REQUEST

(PUD1603-01) Final Development Plan for phase 1 for the 44th St./8th Ave. PUD, for a gas station/convenience store, retail/bank building, drive-through restaurant and three apartment buildings on a parcel of land described as P.P. # 70-14-26-200-077, located at 850 44th St., in a (PUD) Planned Unit Development district, Georgetown Township, Ottawa County, Michigan.

SUMMARY-for the final development plan for phase 1

2. Northwest entrance on 44th St.

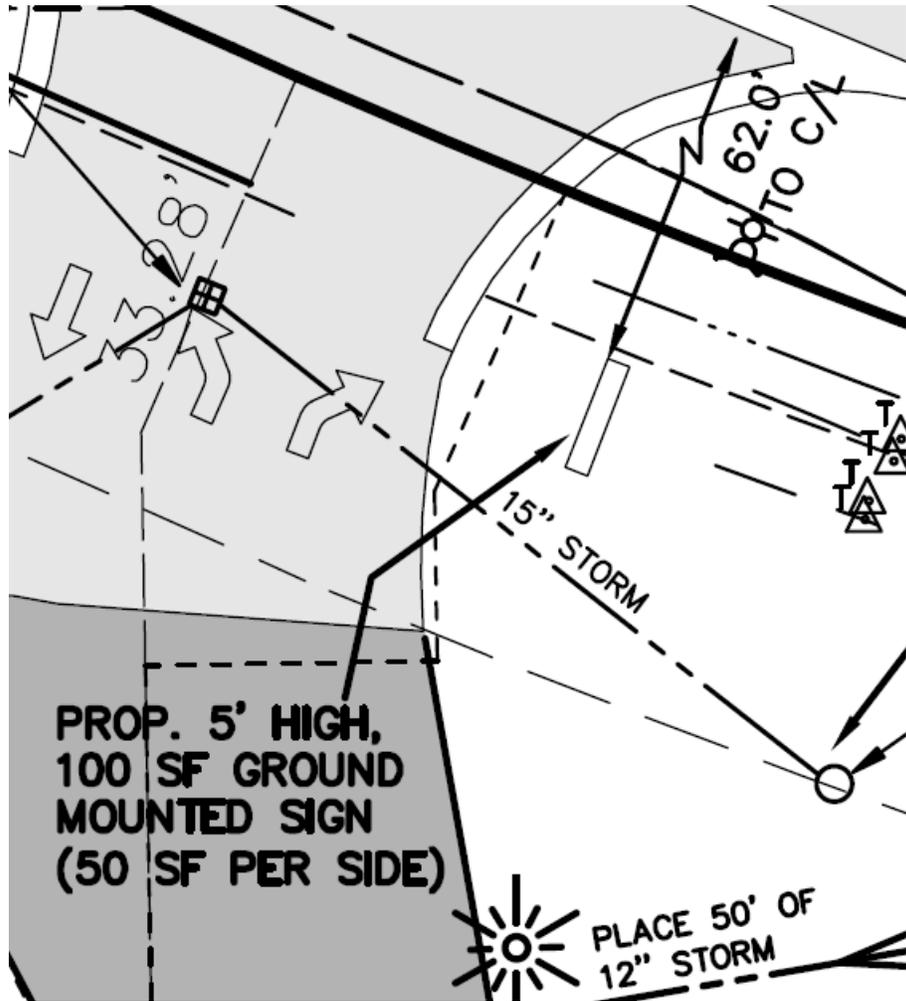
- The right-of way is 50 feet from the centerline of 44th St. Therefore, the sign is proposed to be 12 feet from the right-of-way line. Sec. 25.6(B)(2) requires a minimum of 15 feet to the right-of-way. **The request is for a 3 foot deviation from the ordinance regulations.**
- The sign is proposed to be 5 feet in height. Sec. 25.6(B)(2) requires a maximum height of 4 feet. **The request is for a 1 foot deviation from the ordinance regulations.**
- The area of 50 square feet per side meets ordinance regulations.

- c. **The ground mounted freestanding sign at the northwest entrance on 44th St. is allowed to be 12 feet from the right-of-way line, a deviation of 3 feet from Sec. 25.6(B)(2) which requires a minimum of 15 feet. The sign is proposed to be 5 feet in height, a deviation from Sec. 25.6(B)(2) which requires a maximum height of 4 feet.**

3. Southeast entrance on 8th Ave.

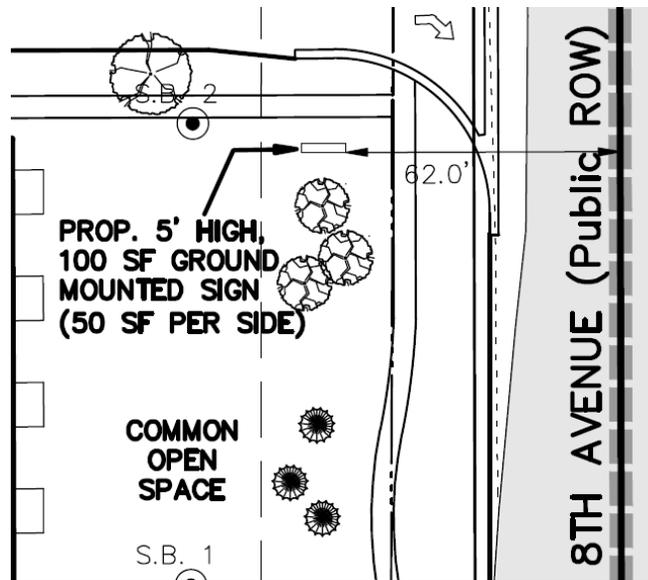
- The setback is to be measured from a point 60 feet from the centerline of 8th Ave. The sign is proposed to be 2 feet from this point and Sec. 25.6(B)(2) requires a minimum of 15 feet. **The request is for a 13 foot deviation from the ordinance regulations.**
- The sign is proposed to be 5 feet in height. Sec. 25.6(B)(2) requires a maximum height of 4 feet. **The request is for a 1 foot deviation from the ordinance regulations.**
- The area of 50 square feet per side meets ordinance regulations.

- d. **For the ground mounted freestanding sign at the southeast entrance on 8th Ave., the setback is to be measured from a point 60 feet from the centerline of 8th Ave. The sign is proposed to be 2 feet from this point and Sec. 25.6(B)(2) requires a minimum of 15 feet. The 13 foot deviation from the ordinance regulations is allowed. The sign is proposed to be 7 feet in height to be similar to architect of the building. Sec. 25.6(B)(2) requires a maximum height of 4 feet. The request is for a 1 foot deviation from the ordinance regulations is allowed.**
